# UNITED STATES PATENT AND TRADEMARK OFFICE

| APPLICATION NO.   | FILING DATE | FIRST NAMED INVENTOR | ATTORNEY DOCKET NO. | CONFIRMATION NO. |
|---|-------------|----------------------|---------------------|------------------|
| 10/570,347  | 06/28/2006  | Francois Girard      | P29468              | 5450             |

### Office Action Summary

**DETAILED ACTION**

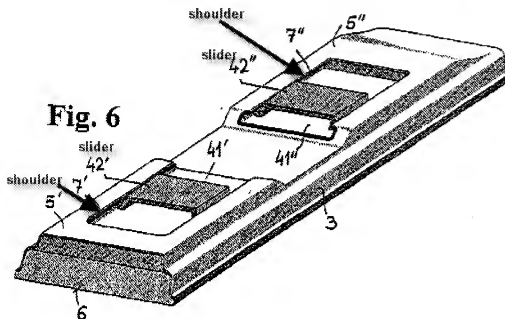
Furthermore, applicant argues that elements 7' and 7'' are not shoulders.

Examiner disagrees with applicant, page 11, lines 9-16 states the following:

The examiner maintains that the cutouts 7', 7'' necessarily have shoulders as annotated by examiner above.
